May 2, 2024
AVO 37449.004

Re: Lane Ranch Phase 1 Preliminary Plat -Review #3

Halff Associates, Inc. was requested by the City of Sanger to review the Preliminary Plat for Lane Ranch Phase 1. The submittal was prepared by Middleton and Associates, LLC and was dated February 2, 2024.

PPT1

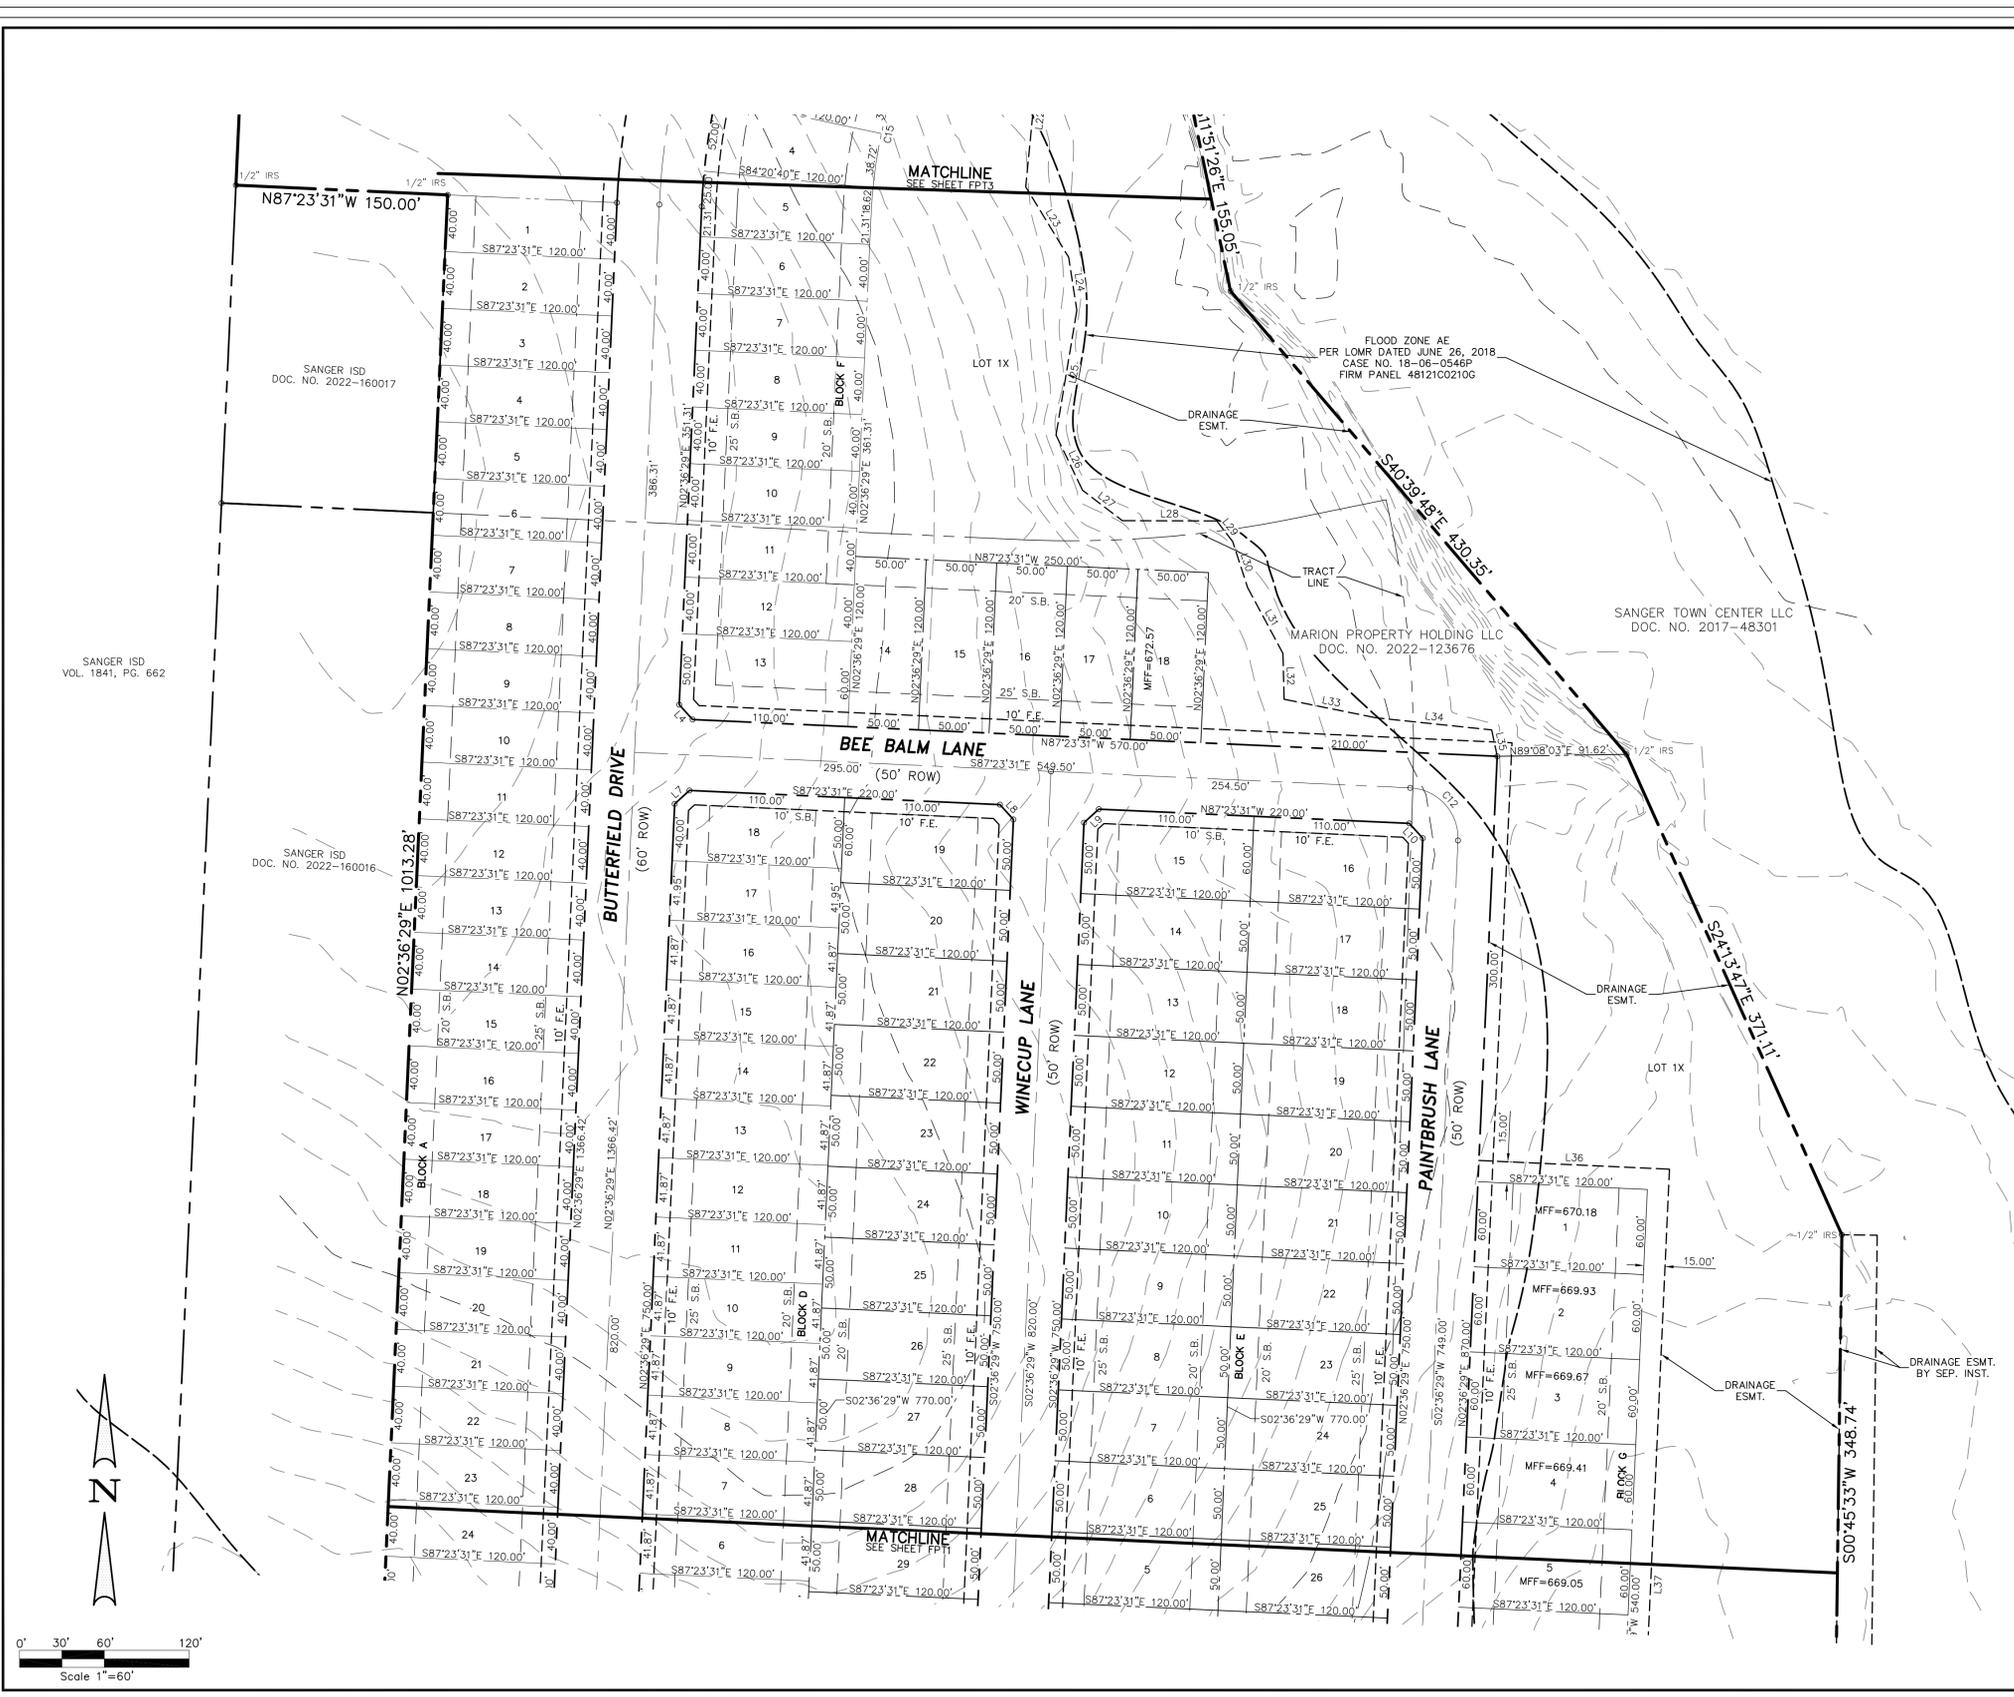
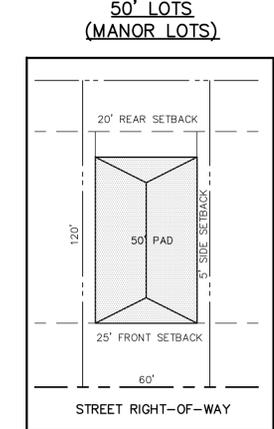
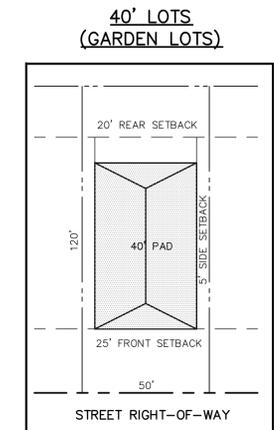
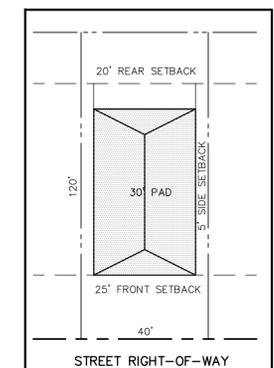
Verify easement boundaries

Verify boundary does not appear to cover the entire floodplain

DE by separate instrument for grading and headwall

PD Ord. called out is for Sanger Circle. The PD approval for Lane Ranch is required for plat acceptance

FPT1

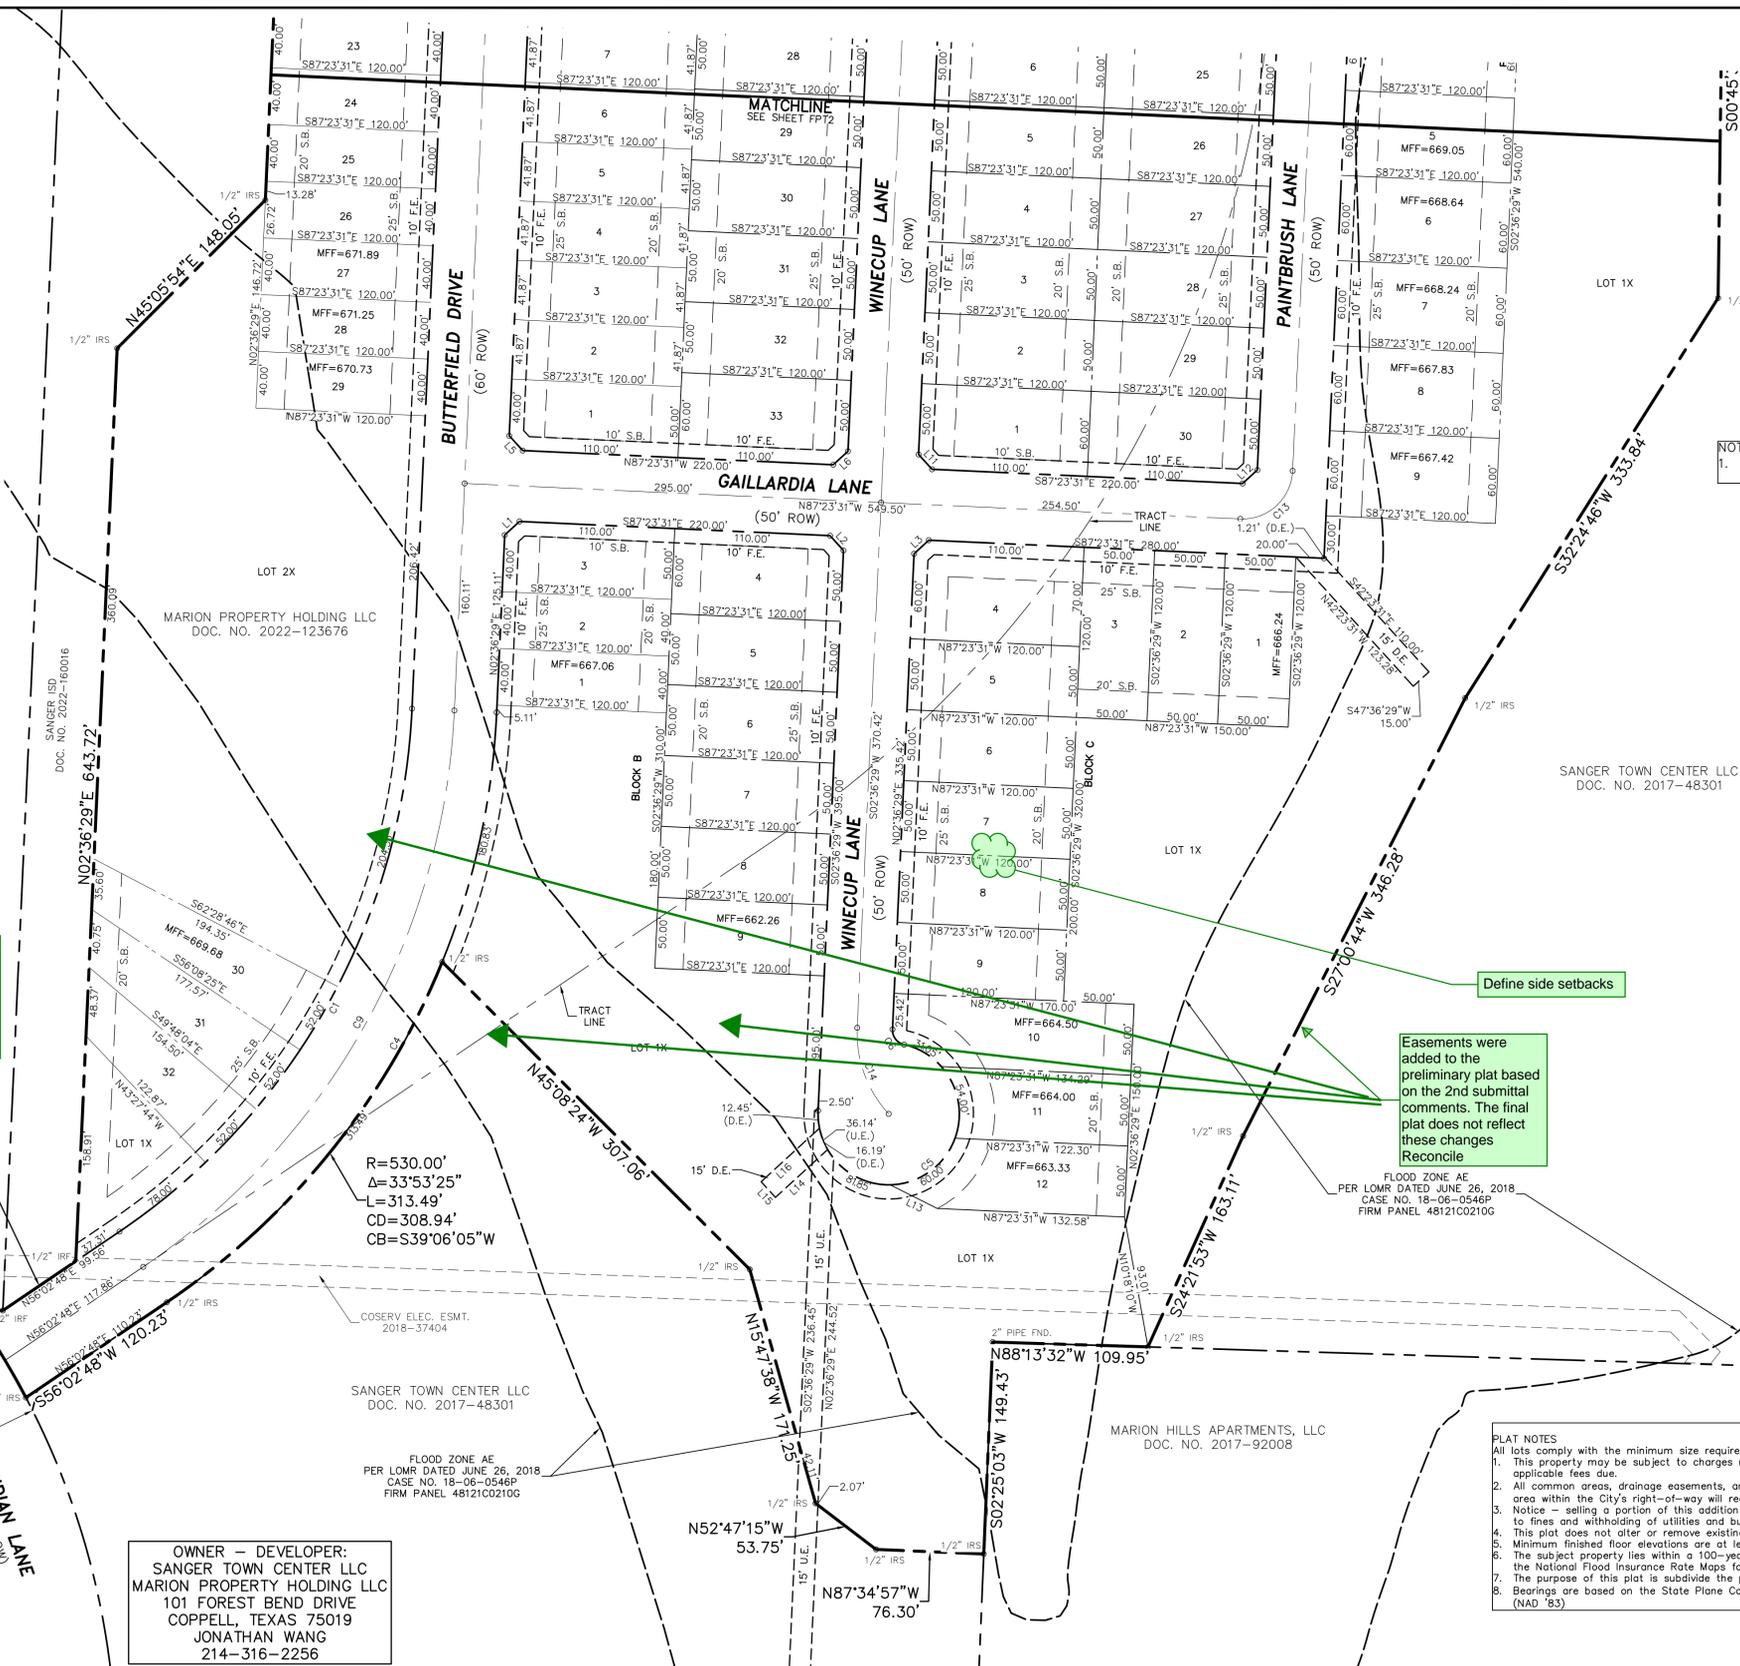
Provide Closure report per ordinance 10.104(d)(10)

Easements were added to the preliminary plat based on the 2nd submittal comments. The final plat does not reflect these changes
 Reconcile

Show centerline of existing street. Dimensions from centerline to edges of existing and proposed right-of-way on both sides of the centerline per ordinance 10.104(d)(10)(H) TYP

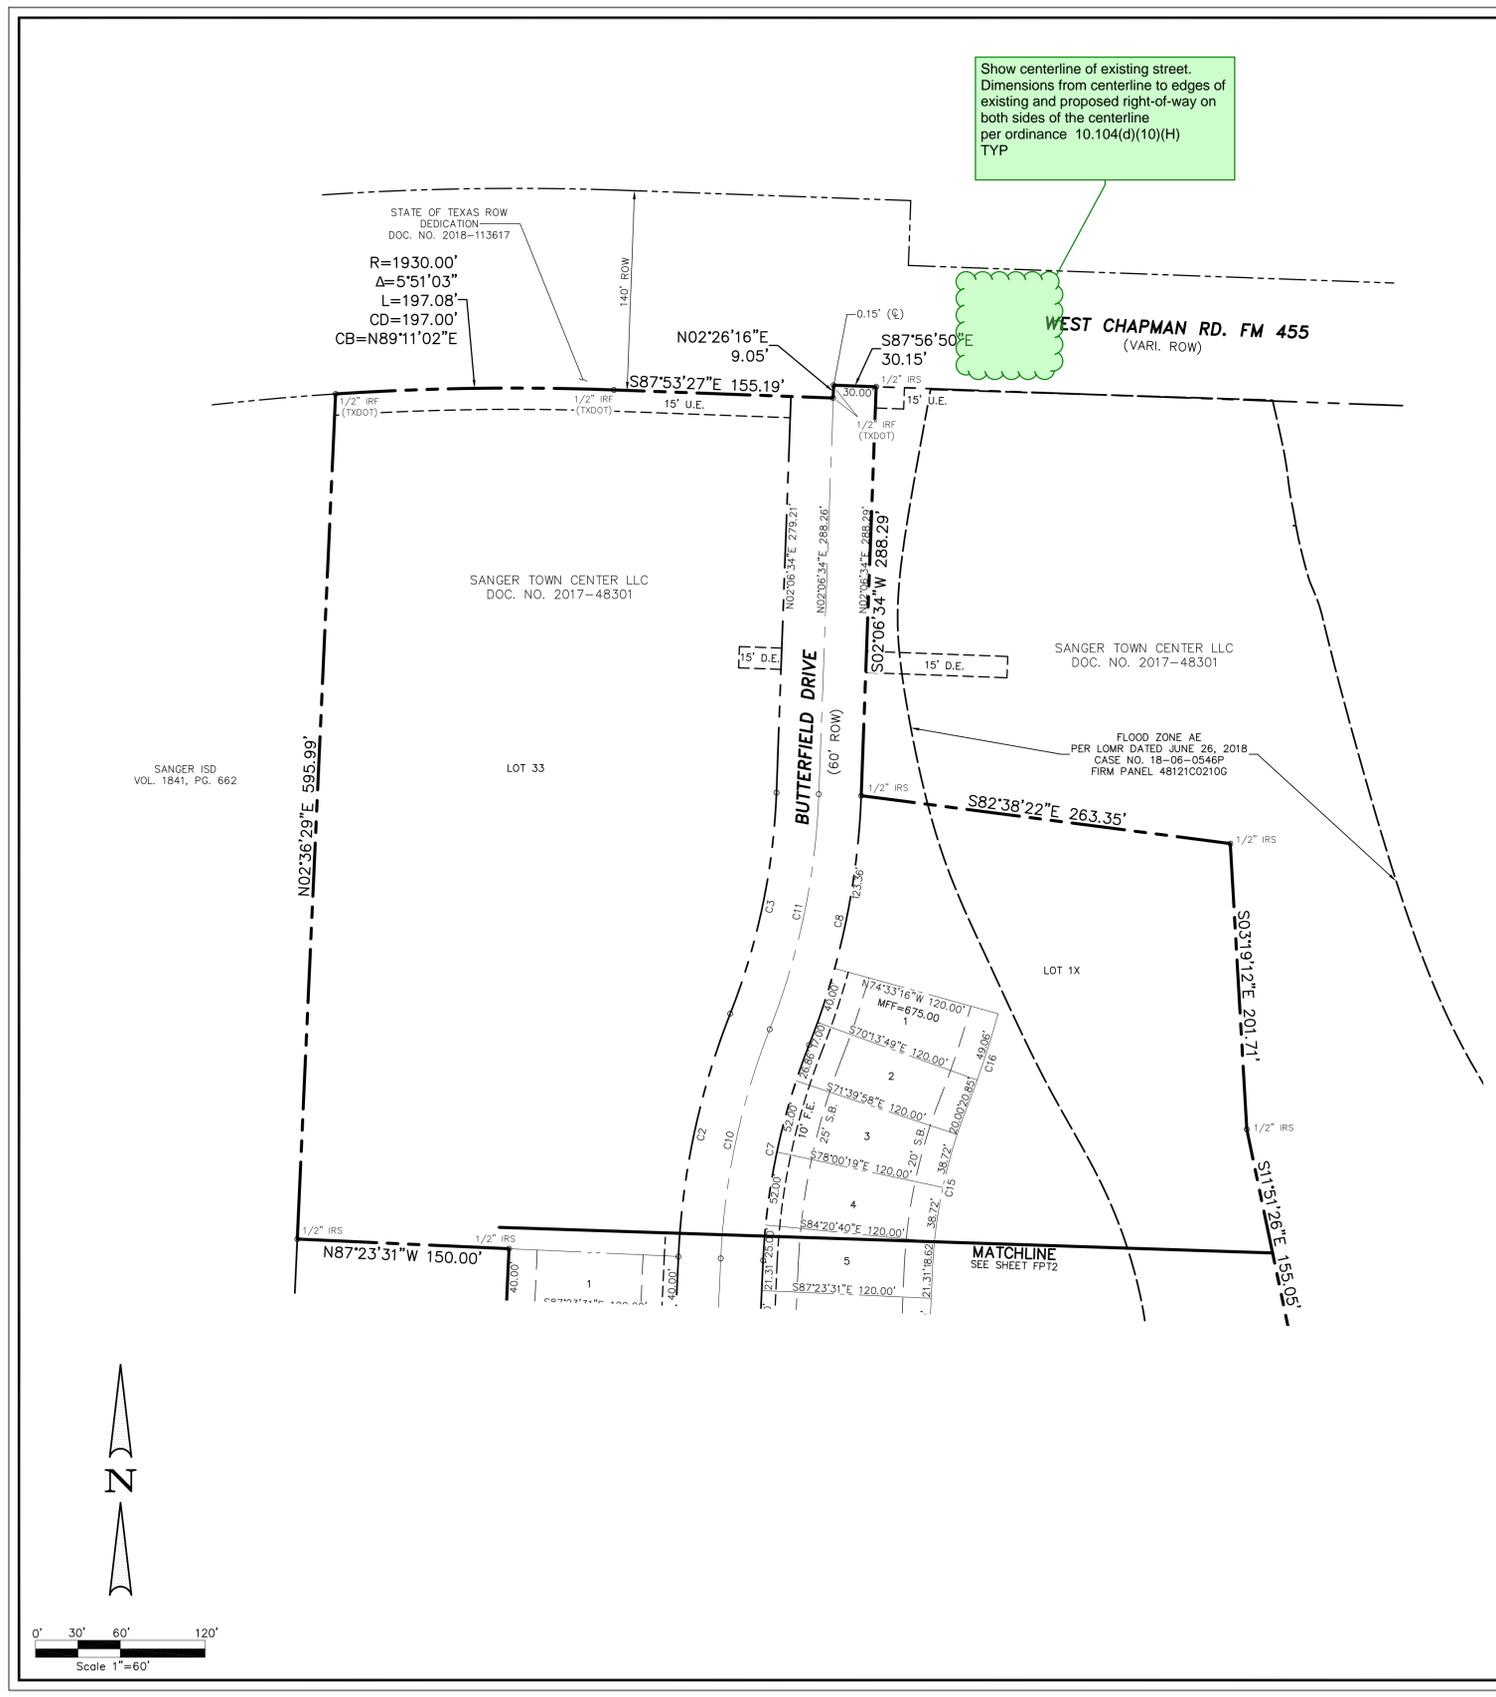
Replace with Final Plat approval per ordinance 10.104(d)(10)(X)

Add 3" x 3" recording box at the lower right hand corner. 10.104(d)(10)(N)
